49 CFR Part 571

[Docket No. NHTSA-2010-0148]

Federal Motor Vehicle Safety Standards; Head Restraints

ACTION: Final rule; technical amendments; response to petitions for reconsideration and petitions for rulemaking.

Figure 1

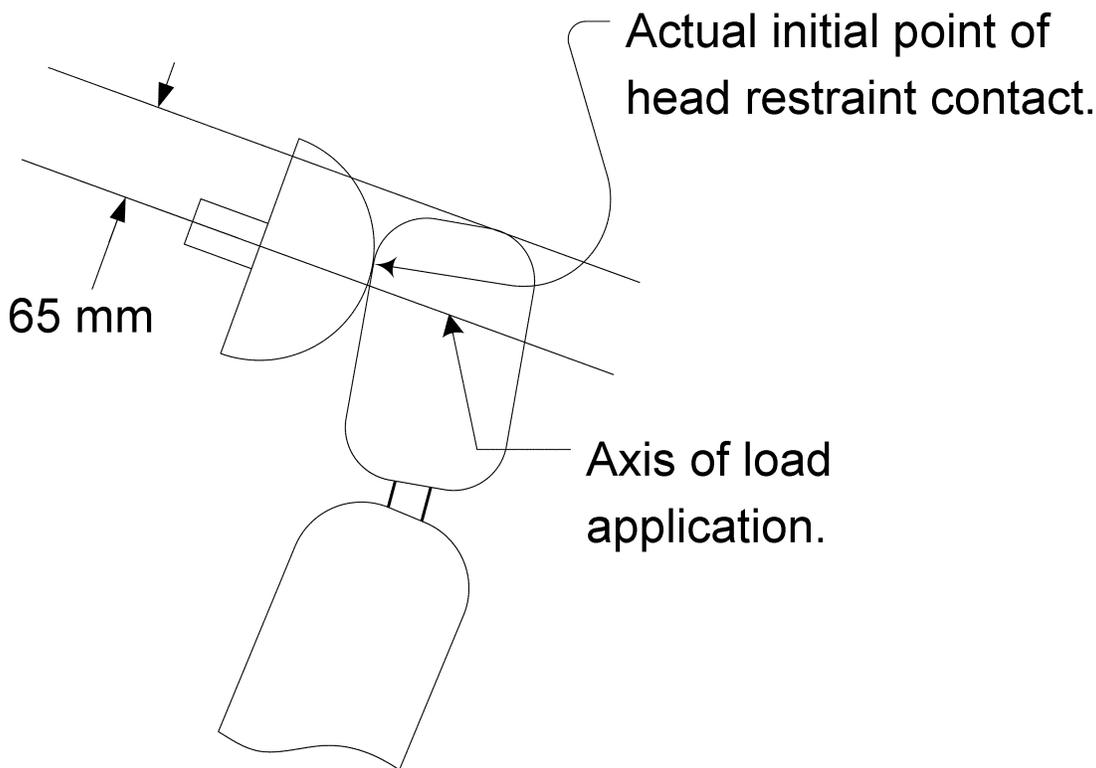
Kongsberg requested that the agency clarify the test procedure in such a way that specifies that the load vector is applied through the centerline of the head form at a height 65 mm +/- 3 mm below the top of the head restraint.

NHTSA believes that the Kongsberg interpretation of the test procedure specified in S5.2.7 of FMVSS No. 202a is correct. In fact, this test is derived from paragraph S5.2 of the version of FMVSS No. 202 now in force, which allows for the use of a cylinder to apply the required force. When a cylinder is used to apply the force, because of the shape or angle of the head restraint, it may not make it possible to assure the point of contact is 65 mm below the top of the head restraint or to do so may result in a position of the axis of load application far from the 65 mm position. However, the axis of load application

can be controlled. Although paragraph S5.2.7 of FMVSS No. 202 specifies a spherical head form loading device, the concept of aligning the axis of load application, represented by the centerline of the head form, remains the same (see Figure 1). Thus, we believe any clarification is simply a technical correction of the existing regulatory text. We are therefore revising S5.2.7(a)(5) to provide this clarification.

We note that the configuration in the illustration is for explanatory purposes only. Other configurations are acceptable if they conform to the text of the standard.
